E4448A-11

S E R V I C E N O T E

PSA Series Spectrum Analyzers with Options 233 and 110,
and Option Driver Assembly p/n E4440-60253

Tuned RF Level Range 2 to Range 3 Switching Time Improvement

Figure 1. Option Driver assembly location.

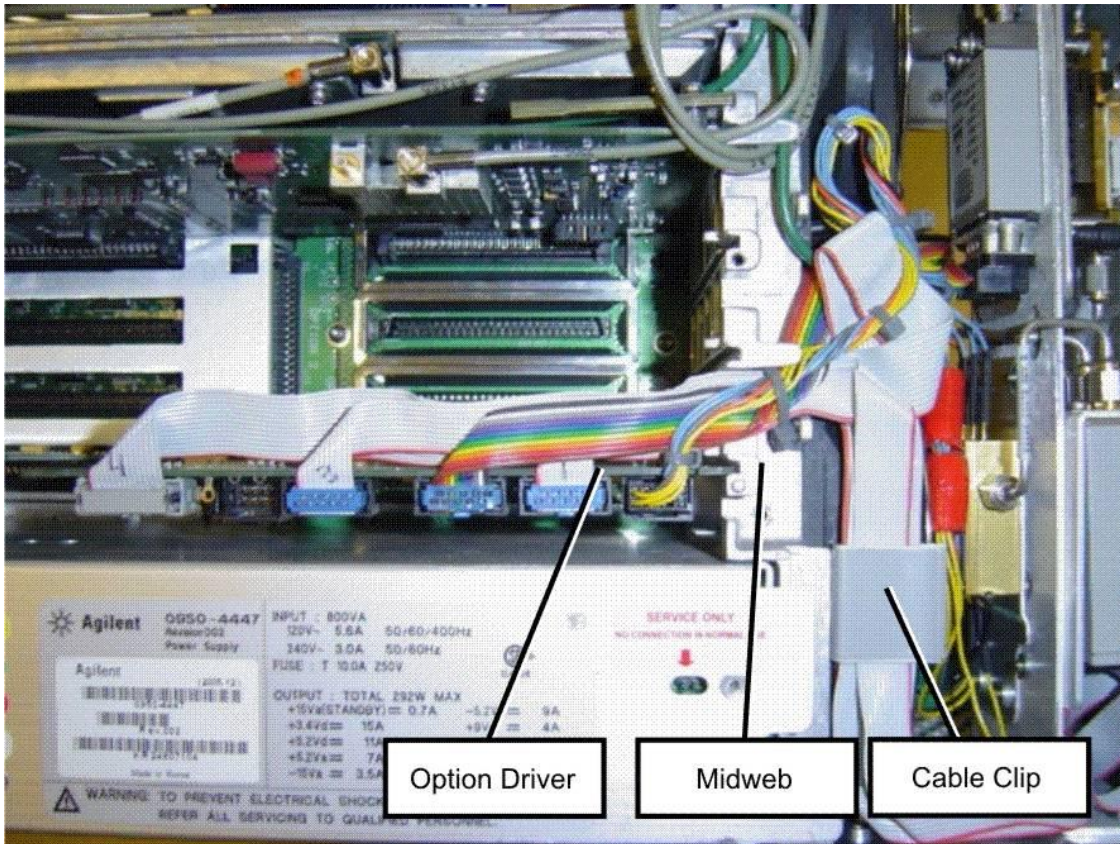
1. Remove the analyzer’s outer case and top brace. See the PSA Service Guide for the procedure to remove and replace these covers.
2. With the instrument powered down, locate the Option Driver assembly shown in **Figure 1**. Notice how the ribbon cables connected to the board assembly are routed near the instrument fans. This

routing prevents damage to the cables when the top brace is installed.

Figure 2. Location of J2 connector

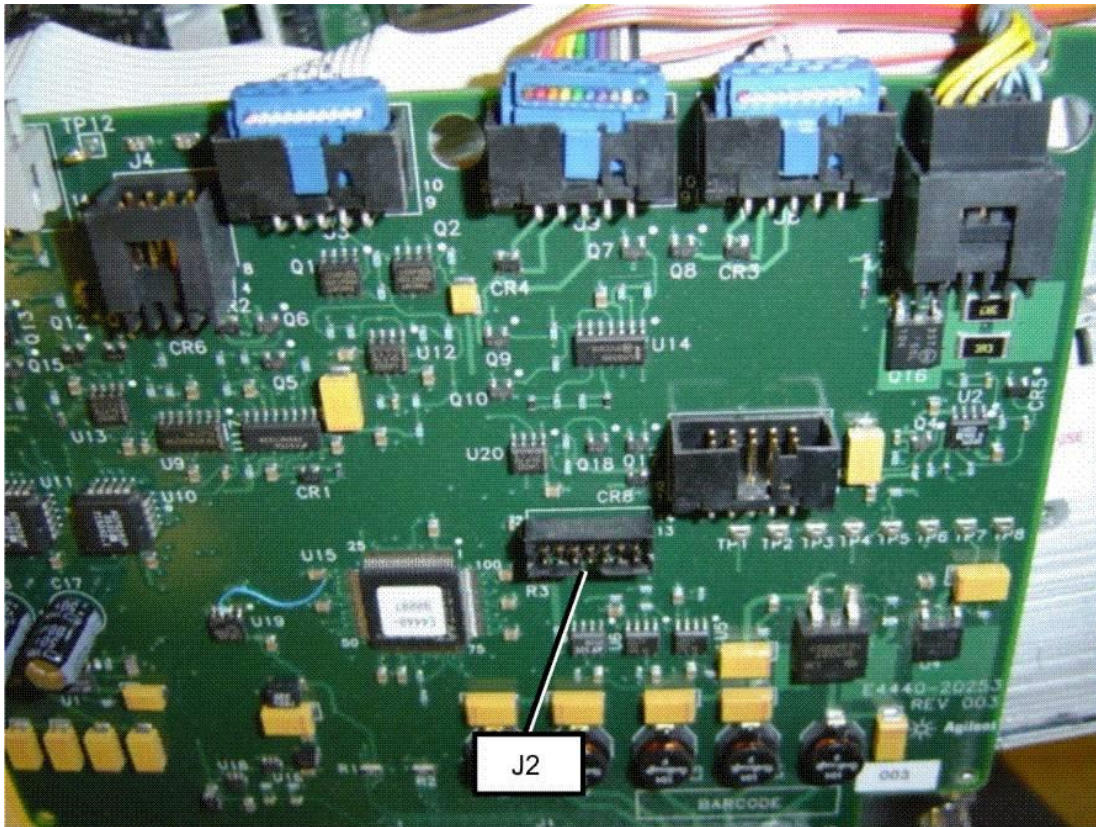
3. Without removing any cables from the option driver, carefully unseat the board assembly from the motherboard. You will need to remove the ribbon cables from the cable clip and possibly remove the cable tie near the mid web. Pull the board out of the instrument only far enough to expose connector J2.
4. See Figure 2. Locate J2 near the middle of the board. Connect the ribbon cable from the Parallel Cable's pod to the JTAG connector, J2, on the A38 option Driver Assembly being careful to align the keying tab on the cable with the J2 header slot.

5. Re-install the Option driver into the instrument being careful to avoid pinching or disconnecting the ribbon cables. Assure the board is fully seated in the motherboard.
